PRODUCT/PROCESS CHANGE NOTIFICATION

PCN APG-ABD/14/8514 Dated 06 Jun 2014

Matrix lead-frame: Additional lead-frame option implementation on VIPower products housed in DPAK package

DPAK FRAME COMPARISON

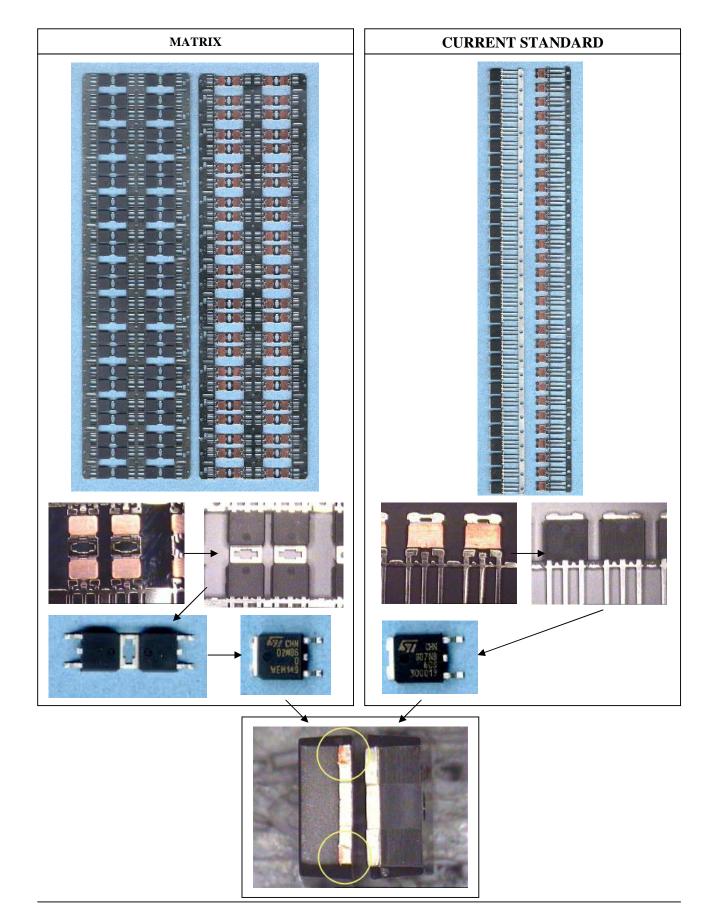
We are going to implement the matrix lead-frame on VIPower products housed in DPAK package as additional lead-frame option. No other material have been changed.

Item	Current	New	
Molding Compound SUMITOMO EME7026		SUMITOMO EME7026	
Die Attach Preform Pb/Ag/Sn		Preform Pb/Ag/Sn	
Bonding wire Al 7 mils, 10 mils		Al 7 mils, 10 mils	
LeadFrame Standard		Matrix	
Lead-plating	Sn 100%	Sn 100%

See enclosed qualification plan and lead-frames comparison
